19/1422MRES_Cranbrook

Thank you for the opportunity to respond to [19/1422MRES Pumping Station near Cranbrook](#)

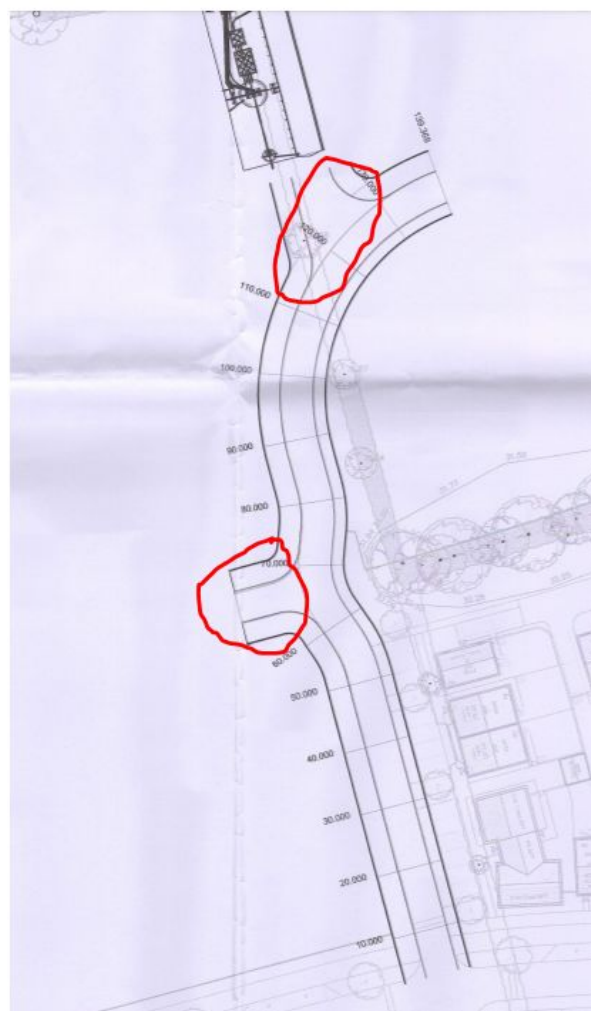
We note and approve of the plan to build a shared use paths for people walking and cycling along the highway of this development.

We would ask you please to consider adopting best practice for the design of the side junctions of this shared use path by designing them so that people walking and cycling have priority over motor traffic emerging from the side roads. This can be done by maintaining the level of the path across the crossing, making it clear with signage and road markings that traffic emerging/entering these side roads does not have priority and using material across

the side roads which clearly demarcates the intended priority.

Adopting such a design begins to make a pedestrian/cycle path safer, enabling people of all ages to choose to walk and cycle. This contributes to the the declared national and county priorities for active travel (as articulated in the NPPF guidance).
